Determination 2017/088

Regarding the code-compliance of a façade system proposed for remediation work to an apartment building at 12 Selwyn Road, Howick, Auckland

Figure 1: Typical construction of the original façade system (not to scale)

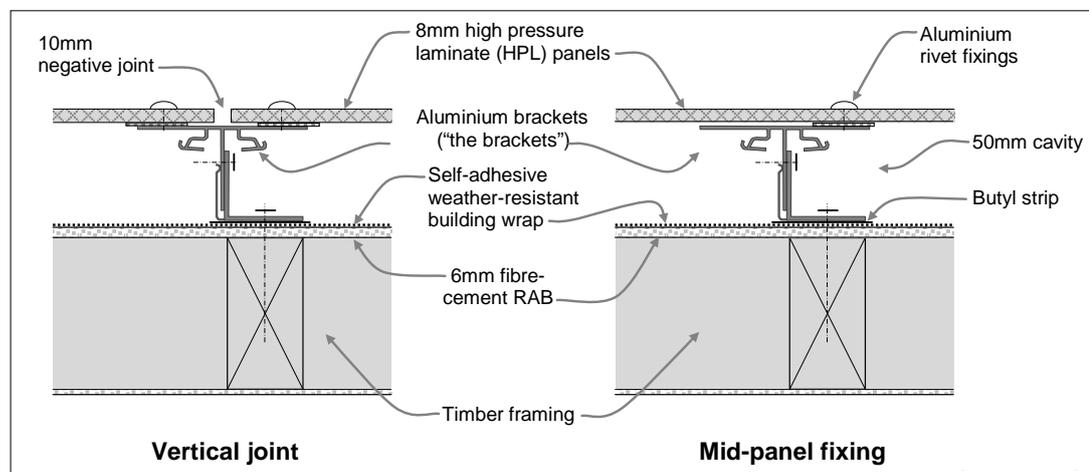
- Fixing with aluminium rivets rather than steel screws would probably cause more panels to fall, or panels to fall sooner – so the change does not improve or maintain performance compared to that in the fire test.
- This might not result in increased flaming above the windows opening, but increases the hazard of falling materials onto fire fighters or others below and fire could spread from falling flaming panels depending on the panel's combustibility.
- Increasing fixing spacing is unlikely to improve performance compared to the fire tested system and whether performance would be maintained is unknown.

- The base assembly is to be timber frame with unspecified cavity insulation instead of steel frame with (mostly likely) glass fibre insulation as tested.
- 6 mm fibre cement sheet is to be used on the outside of the framing instead of [16mm] gypsum plasterboard. The latter would be expected to have much better fire-resistant properties than the former.
- The aluminium support structure differs from that tested.
- The panels are fixed to the support structure with aluminium rivets instead of steel screws as tested.
- The panel fixings may have larger spacings compared to that tested.
- The mineral fibre insulation fire stopping at each level is possibly omitted but present in the test assembly.

- The modified façade system replaces the aluminium rivets with 5.0mm diameter stainless steel rivets spaced in accordance with the tested panels. The proposed steel rivets have a greater cross section than the tested screws, so should perform equally if not better than the tested wall.

Figure 2: The original, modified, and 285-tested façade systems (not to scale)

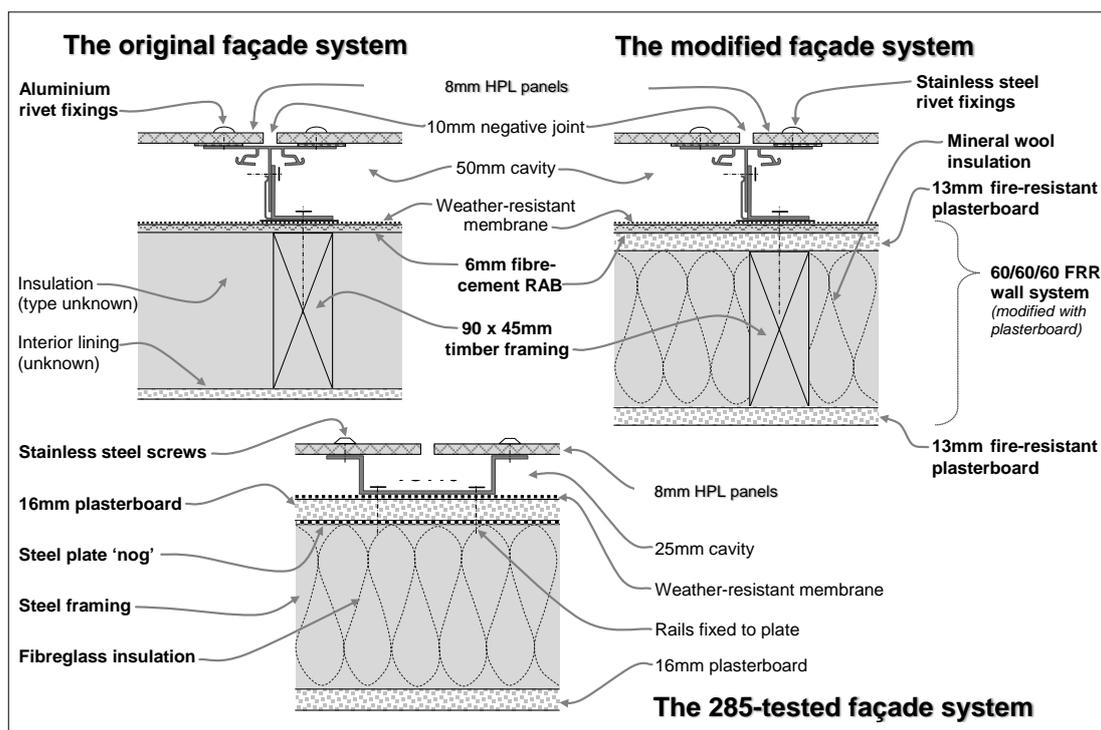
5.2.4 The fire scientist noted that components of the base wall assembly used in the tested wall as shown in Table 2 would provide little fuel should an exterior fire breach the outer layer of gypsum board and reach the framing and cavity insulation (see Figure 2).

Component	Differences identified	Additional information provided / the modified façade system
1 Base wall assembly	Timber frame with unspecified cavity insulation instead of steel frame.	Base wall to be an established 60/60/60 FRR timber-framed wall, with additional layer of 13mm fire-resistant plasterboard beneath the fibre-cement RAB.
	6mm fibre-cement RAB to outside of framing instead of 16mm gypsum plasterboard.	
3 Aluminium support structure	Aluminium support structure for the HPL panels differs from that tested.	<ul style="list-style-type: none"> Proposed structure has same physical properties as tested product. Dead load, seismic and wind loads drive the support structure sizing.
4 Panel fixing method	Panels fixed to support structure with aluminium rivets instead of steel screws.	Stainless steel rivets to be used.
5 Spacing of fixings	Fixings may have larger spacings compared to that tested.	Spacing to accord with NFPA 285 test.

6 Insulation and cavity barriers	Mineral fibre insulation fire stopping at each level is possibly omitted but present in the test assembly.	Cavity barriers are required and will be installed. There is no intention to delete these.

5.8.2 The fire scientist reviewed the modified façade system taking into account fire test results for the proposed base wall. Some concerns were discussed with the fire consultant, who provided an amended proposal (see Table 4) that included an additional layer of 13mm fire-resistant plasterboard beneath the fibre-cement RAB.

- 6.5.3 Taking the fire scientist's report into account, I am satisfied that sufficient evidence has been provided to demonstrate that the modified façade system will, in this case, satisfy Clause C3 Fire affecting areas beyond the source. However, as noted by the fire scientist, a compliant system should incorporate fire stopping at each floor level in the building: this detail has not yet been provided.
